BTR-800 Audio Board Auxiliary Input Internal Modification (I/C B)

(Raw Board No. 750608 Rev A)

CONNECTION DETAILS:

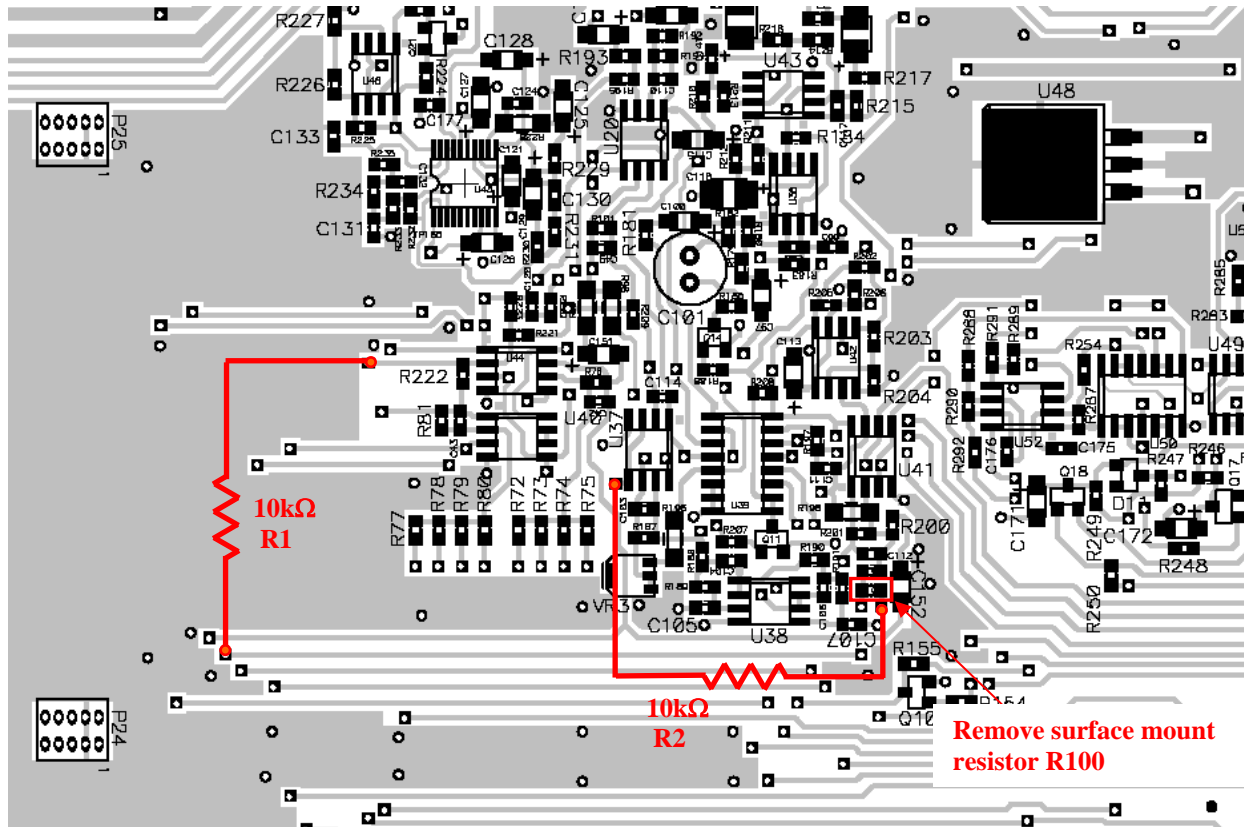
PURPOSE: This modification “disconnects” auxiliary input audio from being placed onto any wired intercom system connected to the unit on the **intercom B** side. The auxiliary input audio will be heard locally, within the base station and its’ belt packs, but not sent to the wired interface. This modification does not affect auxiliary audio out, thus auxiliary out will contain I/C B audio, which is composed of all locally generated audio (base and belt packs) and all wired intercom audio.

1. Remove surface mount resistor R100 (10k Ω) located to the left of C152.
2. Solder R1 from the auxiliary trace to pin 2 of U44 (located just above U40) via the trace extending from U44.
3. Solder R2 from the right side pad of the removed resistor R100 to pin 5 of U37.

NOTE: Resistors R1 and R2 are 10k Ω and 1/8 Watt. Ensure the resistor leads cannot short to ground or another trace. Small diameter heat shrink may be used over the leads to insulate them.
